**ARCHITECTURAL REVIEW BOARD  
CITY OF FREDERICKSBURG, VIRGINIA  
AGENDA  
September 12, 2016  
7:00 P.M.  
COUNCIL CHAMBERS, CITY HALL**

**TO:** ARCHITECTURAL REVIEW BOARD  
**FROM:** Kate Schwartz, Historic Resources Planner  
**DATE:** August 8, 2016  
**SUBJECT:** Certificate of Appropriateness for demolition and new construction at 100 Hanover Street  
 1<sup>st</sup> review for demolition and site planning, scale, and massing

100 HANOVER STREET

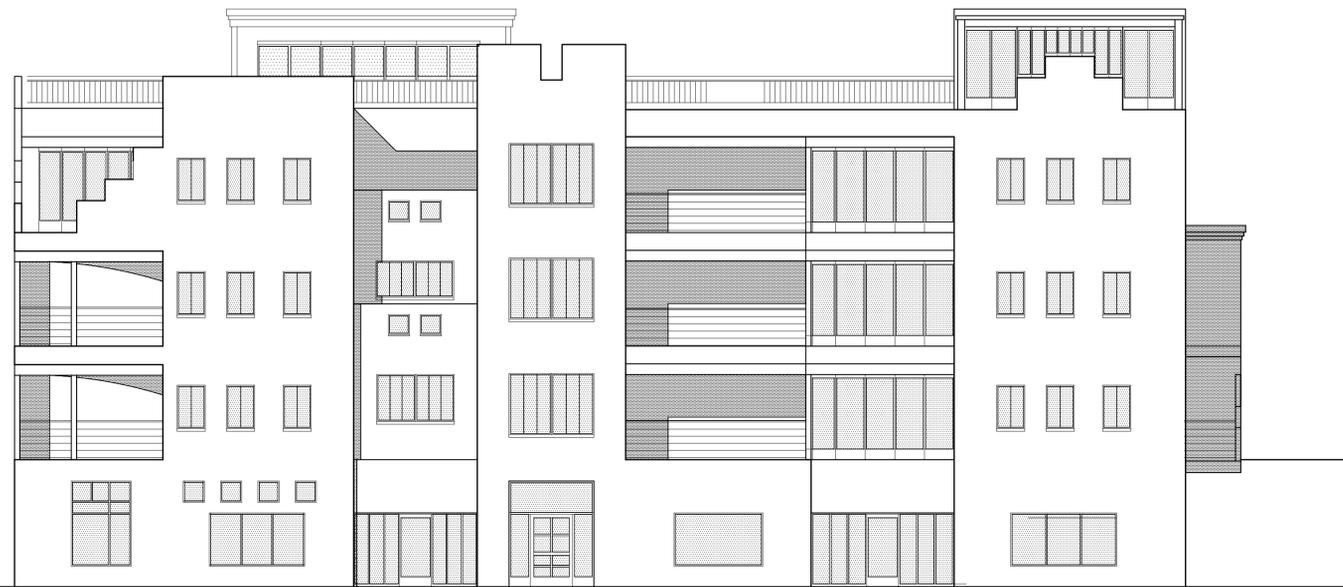
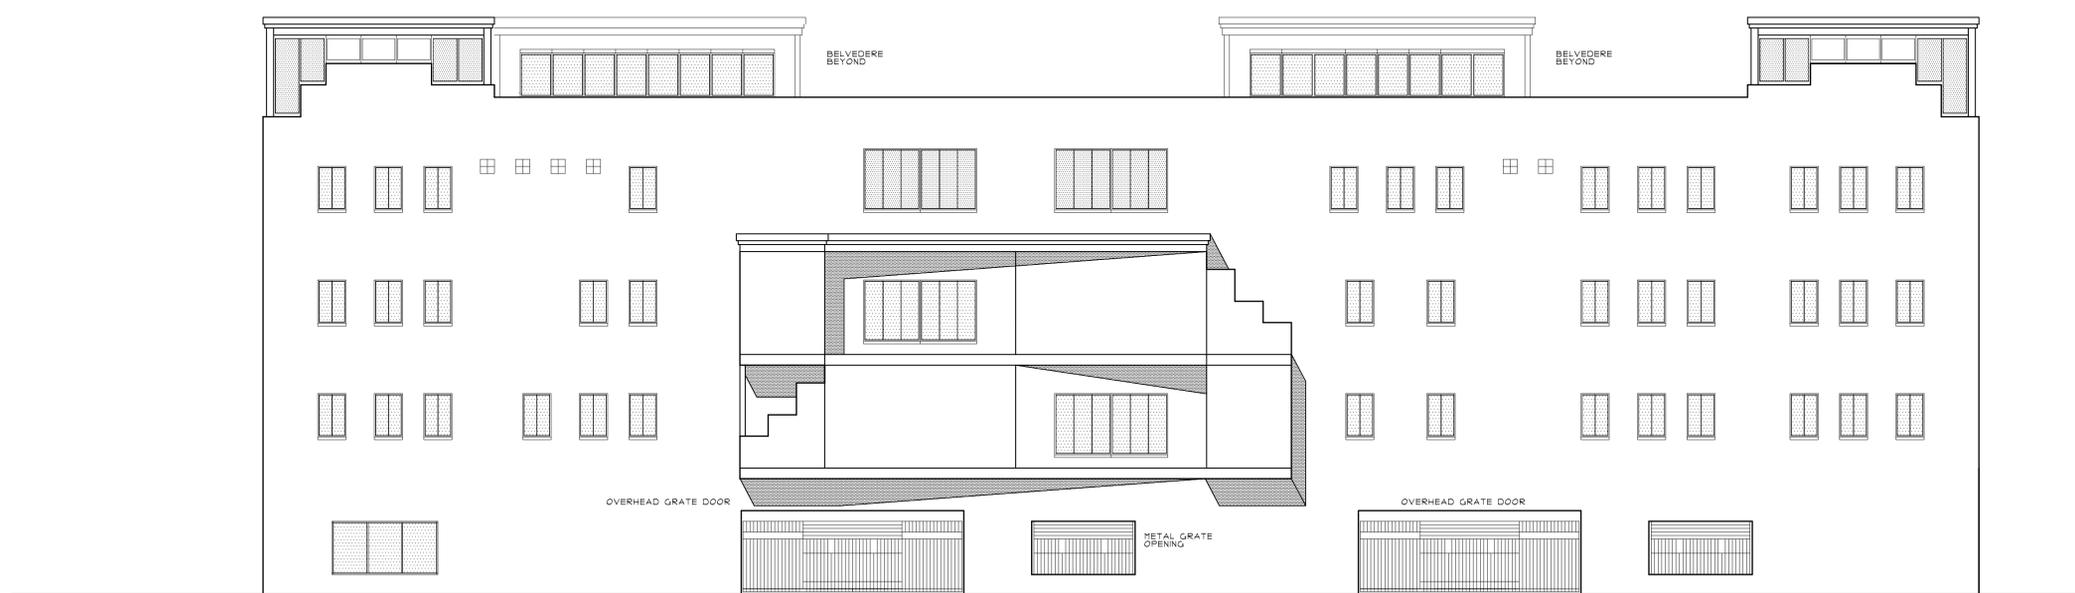
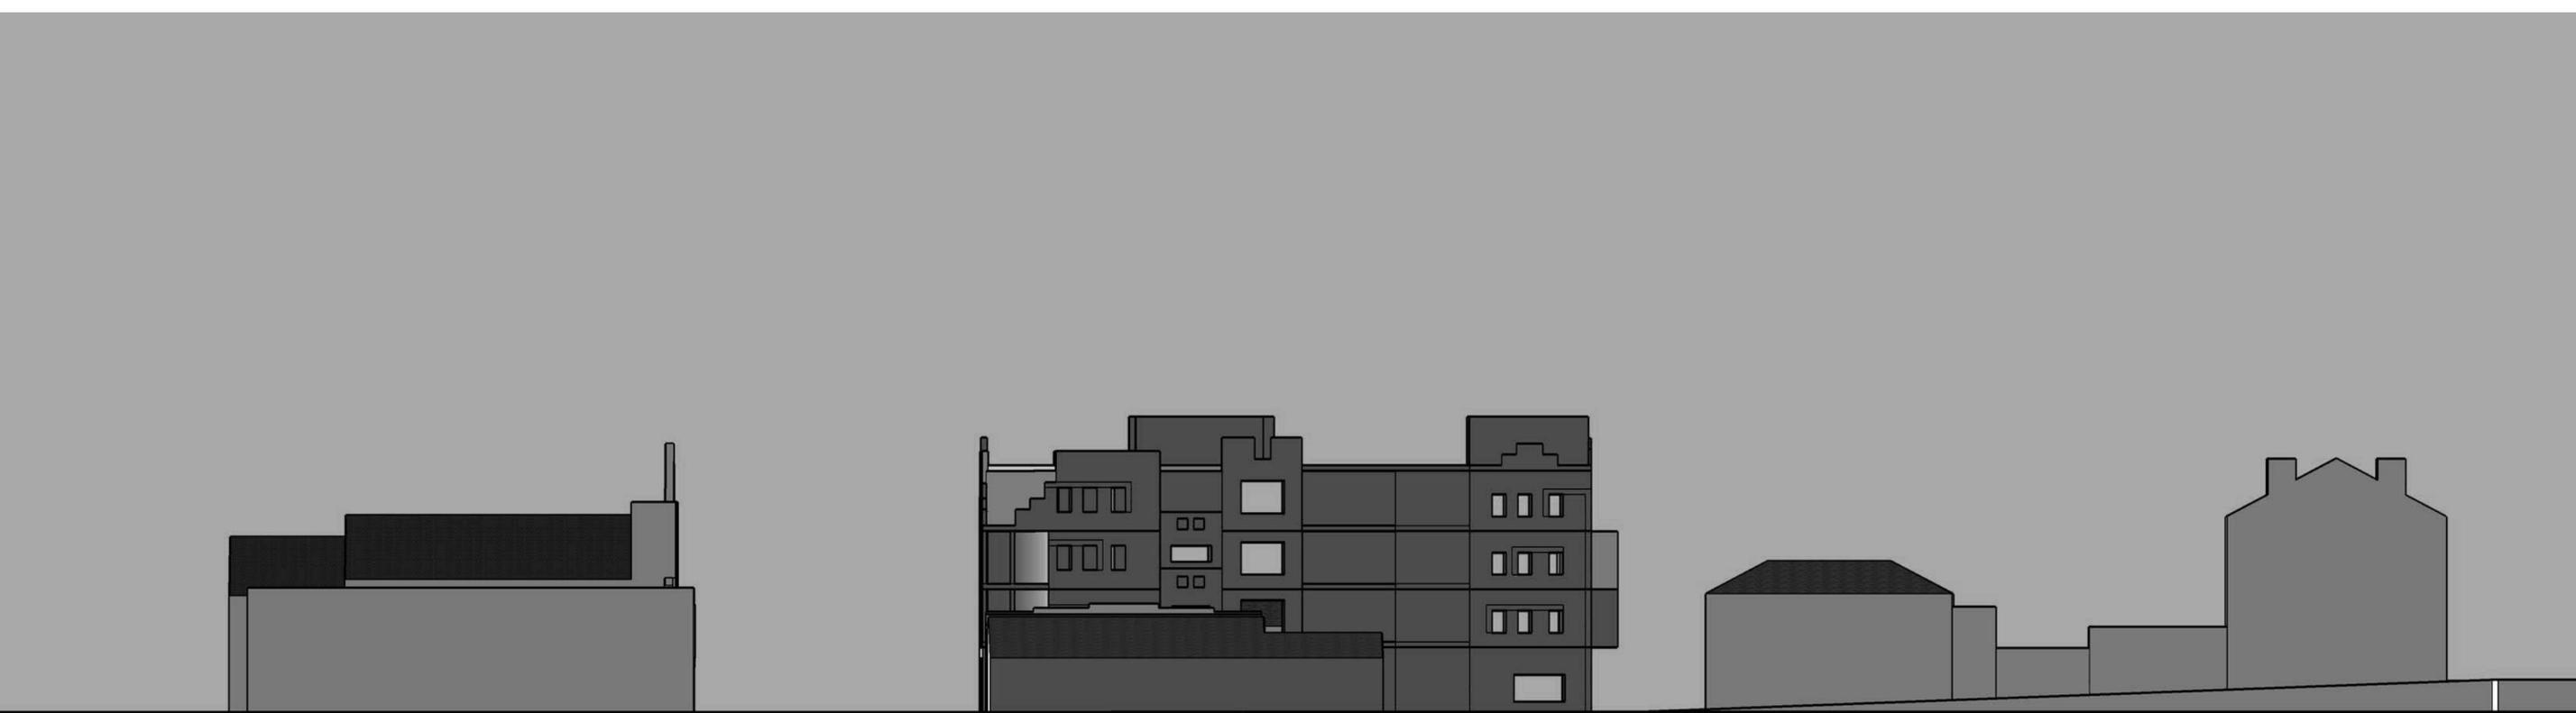
**The site planning, scale, and massing meet the standards and guidelines for the Historic District and approval is recommended.** Architectural details, including windows, doors, storefronts, cornices, wall surfaces, materials, and other elements will be considered at a second public hearing. Compatibility with the character of the District can be increased through these additional elements, and items that the Board and applicant may wish to address include:

- Clear delineation of the ground floor and storefronts through materials, coloration, and/or the addition of a cornice or other physical element
- Variations in the color and materiality of bays to provide clear differentiation and mitigate the impact of the building's scale
